Re: Zoning Commission Case No. 25-13 – Text and Map Amendments to Create New  
Wisconsin Avenue Mixed Use Zones

### 4800 Wisconsin Ave, NW Zoning Diagram

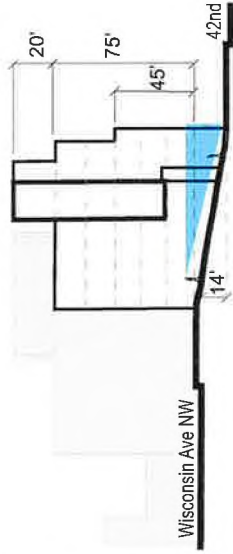
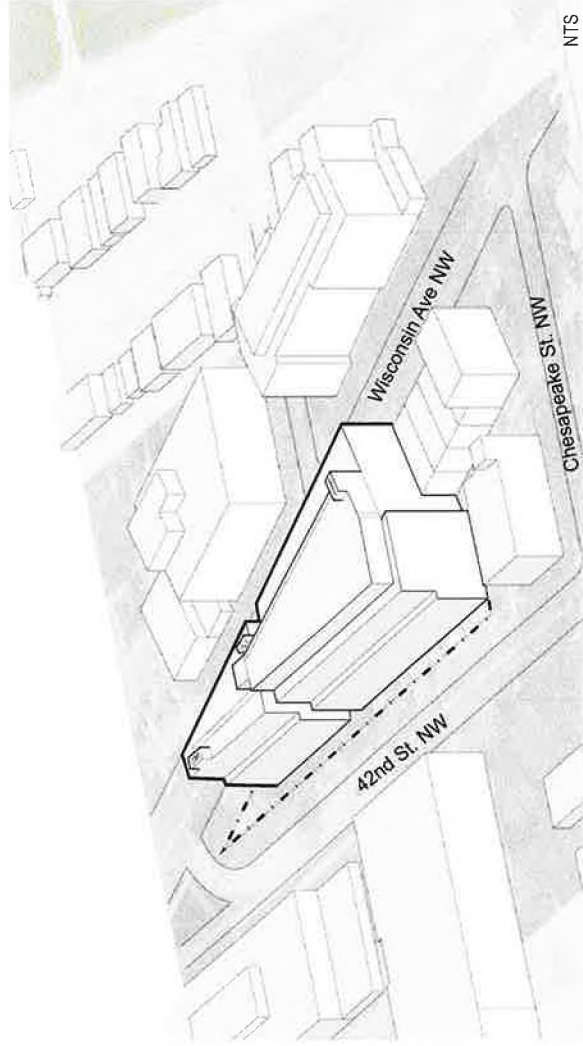
As depicted in the attached Zoning Diagram, there are numerous problems with requiring an east-west pedestrian corridor in Square 1733 that is aligned with Davenport Street, NW.

**Connectivity** - One of the biggest issues with the requirement to align the pedestrian corridor with Davenport Street, NW is the significant change in grade (14 feet) that exists from Wisconsin Avenue, NW down to 42<sup>nd</sup> Street, NW at Davenport Street, NW. This change in grade creates significant ADA accessibility issues for pedestrian connectivity, as the only realistic way to satisfy ADA requirements would be to introduce an exterior public elevator within the pedestrian corridor. In addition, Section 1008.1(a)(3) notes that the purpose of the pedestrian corridor requirement is to provide clear sightlines between the connecting streets. Due to the change in grade at this location the sightlines between the two streets are significantly obscured, especially from 42<sup>nd</sup> Street, NW looking towards Wisconsin Avenue, NW.

**Building Massing/Marketability of Residential Units** – The shape of the Property north of Davenport Street, NW comes to a sharp point as 42<sup>nd</sup> Street, NW meets Wisconsin Avenue, NW. This shape of the Property and the requirement that the pedestrian corridor be uncovered for at least 75% of its length drastically impacts the marketability of the residential units that can be created north of the pedestrian corridor. Providing the necessary hallway in this northern portion of the building will result in residential units that are only 15 feet deep, rather than 35 feet deep which is more typical for residential units.

**Actual Use of the Corridor Area** - In addition, given the relatively short distance that exists between Davenport Street, NW and the intersection of 42<sup>nd</sup> Street, NW and Wisconsin Avenue, NW, it is questionable whether people will actually utilize the required pedestrian corridor, especially given the number of stairs that will be necessary to address the 14 feet of grade change. Also, the need for the stairs in the pedestrian corridor will also limit the potential areas that can be used for commercial frontage or outdoor seating that are contemplated in Section 1008.1(a)(5).
